Robintex (Bangladesh) Ltd. (Extension)

Vulta, Rupgonj, Narayanganj

21 April 2024

Observation 7: Corrosion on steel members (All Over Print Shed And Chemical Store Shed), Digital Printing-02 Shed & New Utility (MS Lario) Shed).

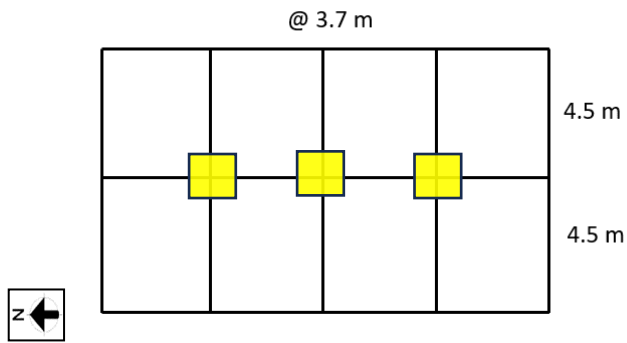
Description: Corrosion was found on steel members at several locations. The building engineer is required to provide rust-proof paint on steel members to protect them from corrosion.

Observation-08: Stress in column exceeds normal design limit (Workshop Building).

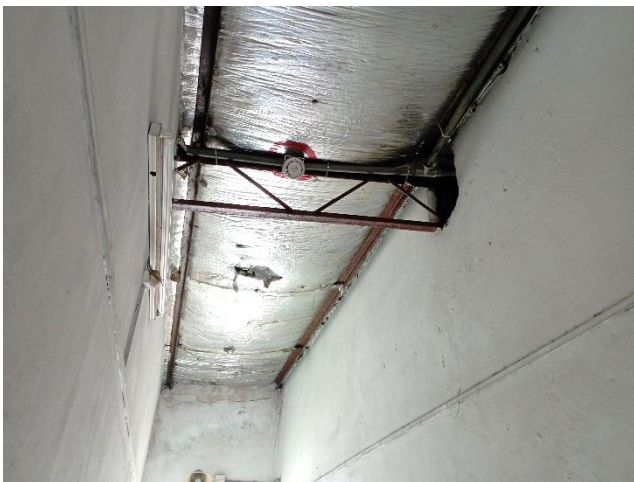
Description: No design documents & geotechnical investigation reports were available on site. The cursory calculation indicates that stress in the marked columns exceeds the normal design limit considering the live load of 2 kPa for typical floors (rest house). We have considered minimum concrete strength (14.10 MPa) based on aggregate type.

The building engineer is required to review, design, and column stresses based on in-situ concrete strength. Produce and actively manage load plans for all floor plates based on floor, column, and foundation capacities.
